**REVIEW OF FORECAST EXPENDITURE:
SECOND REGULATORY PERIOD**

Manila Electric Company

ADDENDUM

ENERGY REGULATORY COMMISSION

Adjustments to Forecast Capital Expenditure (PhP million, real)

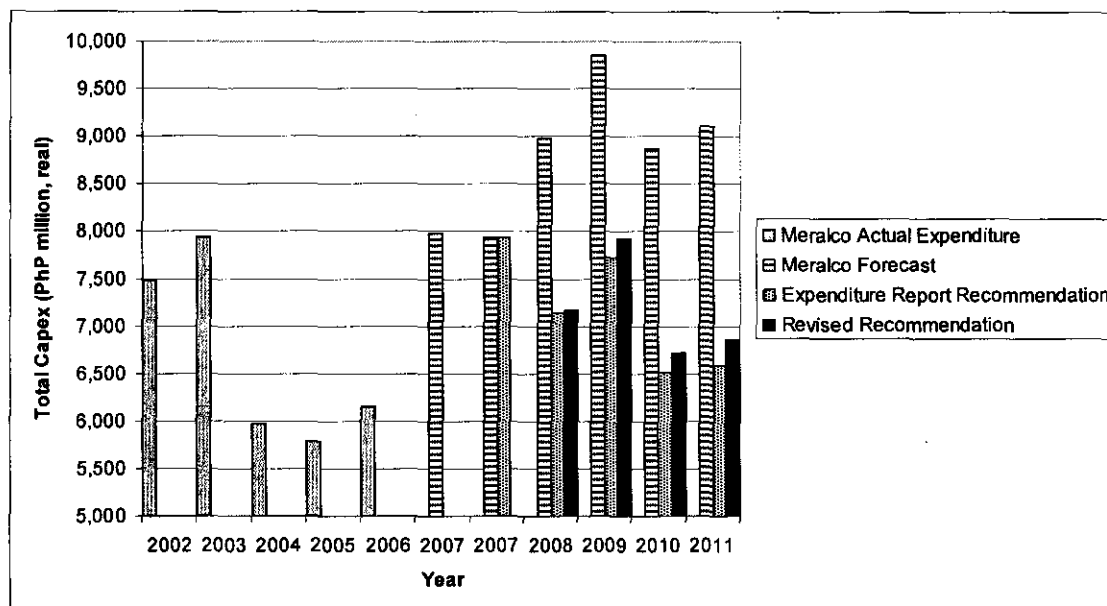
The three proposed adjustments relate to the following:

- At the public consultation Meralco submitted that a larger transformer at Amadeo was required to accommodate a load transfer from Sector 3. We are satisfied that this load transfer was prudent and was not taken into account in the expenditure report.

- The adjustment for the capex in the cost of growth related service drops results from an error in the expenditure report where the average cost of service drop installation was underestimated. We have recalculated the appropriate provision for new service drops on the basis of updated information.

- We accept Meralco's submission that the meters optimized out of the valuation asset base do not actually exist. However we do not fully accept Meralco's submission on growth related metering costs and we believe that our revised provision is a realistic estimate if all new customer meters are purchased rather than drawn from existing stock. , Meralco's records of its metering assets are inaccurate, as they have not been cleansed of meters that have been withdrawn from service.

We recommend that the ERC make the following adjustments to the forecast capital expenditure recommended in PB Associates' expenditure report.

Adjustment to Forecast Operations and Maintenance Expenditure (PhP million, real)

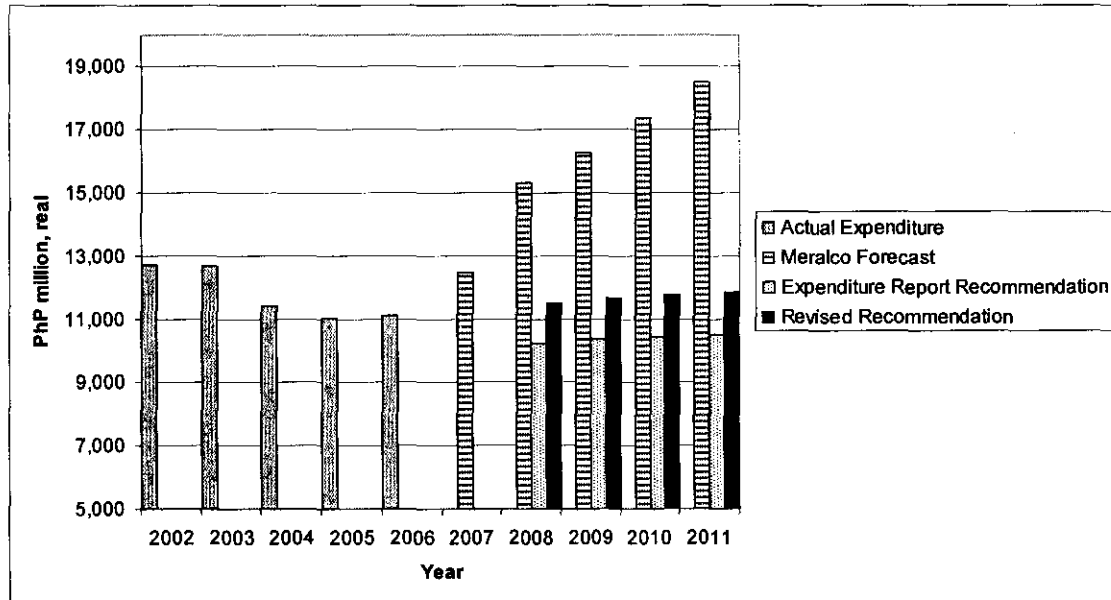
The three proposed adjustments relate to the following:

- Meralco has submitted that it has a backlog in its asset inspection and testing program. We have recommended an adjustment to allow Meralco to eliminate this backlog over the second regulatory period based on our belief that such a backlog could adversely impact network reliability.
- We accept Meralco's submission that the bad debt provision in its revenue application was net of forecast recoveries and have recalculated a reasonable provision on this basis.
- Meralco made an error in its revenue application opex forecast in that its estimated provision for employee pensions and benefits in 2006 was well below the actual expenditure later reported. We are satisfied that this was a genuine error. As our opex forecasting model used the estimated 2006 opex as a key input we have reforecast this line item on the basis of Meralco's actual 2006 expenditure.

We recommend that the ERC make the following adjustment to the forecast operations and maintenance expenditure recommended in the expenditure report.
